October 29, 1985
ST-HL-AE-1465
File No.: G9.17

South Texas Project
Units 1 and 2
Docket Nos. STN 50-498, STN 50-499
Responses to DSER/FSAR Items
Regarding Section 9.1

<u>Attachment</u>	<u>Item No.*</u>	<u>Subject</u>
1	F 9.1-1	Update of Section 9.1 to reflect spent fuel rack configuration

Fuel Handling Machine
Figure 9.1.4-2

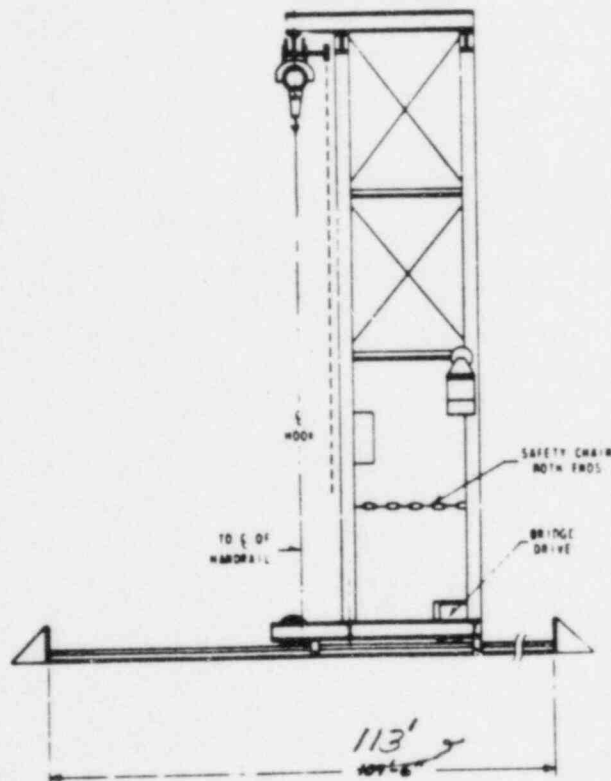
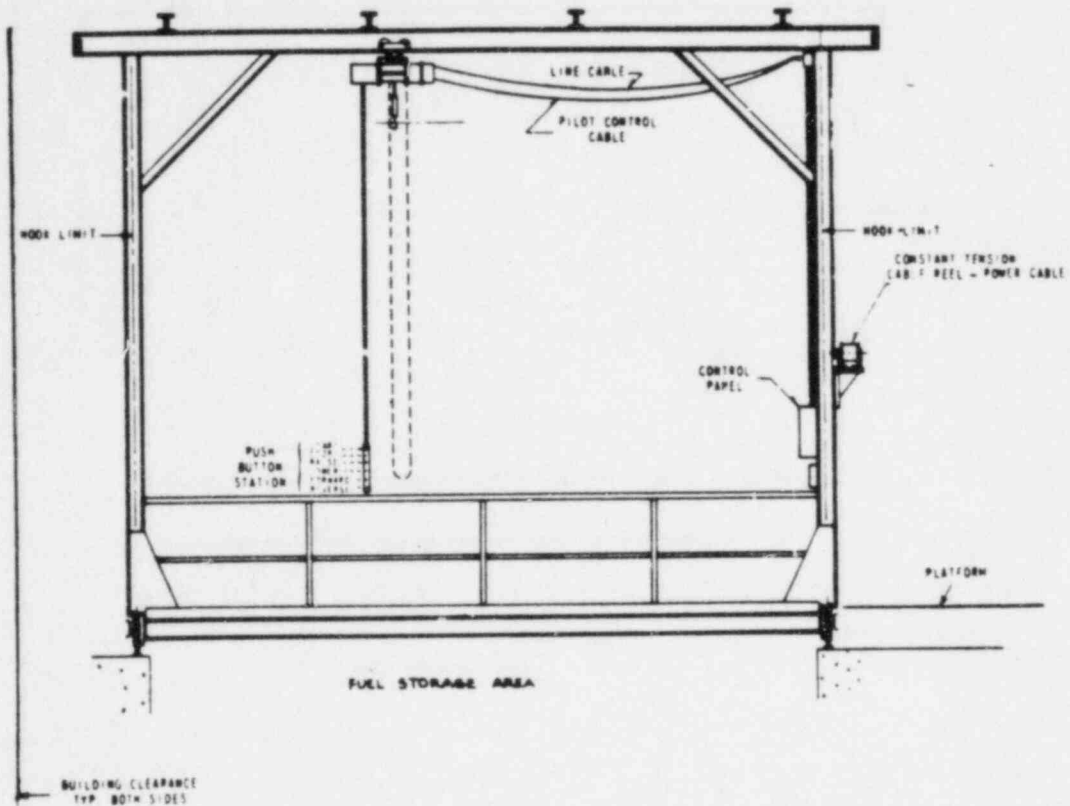
9.1.4.3.4 Radiation Shielding: During all phases of spent fuel transfer, the gamma dose rate at the surface of the water is 2.5 mR/hr or less. This is accomplished by maintaining ~~a minimum of~~ 10 ft of water above the top of the fuel assembly during all handling operations. approximately

The two machines used to lift spent fuel assemblies are the refueling machine and the fuel handling machine. The refueling machine contains positive stops that prevent the top of a fuel assembly from being raised to within ~~a minimum of~~ 10 ft of the normal water level in the refueling cavity. The hoist on the fuel handling machine moves spent fuel assemblies with a long-handled tool. Hoist travel and tool length likewise limit the maximum lift of a fuel assembly to within ~~a minimum of~~ 10 ft of the normal water level in the spent fuel pit. approximately
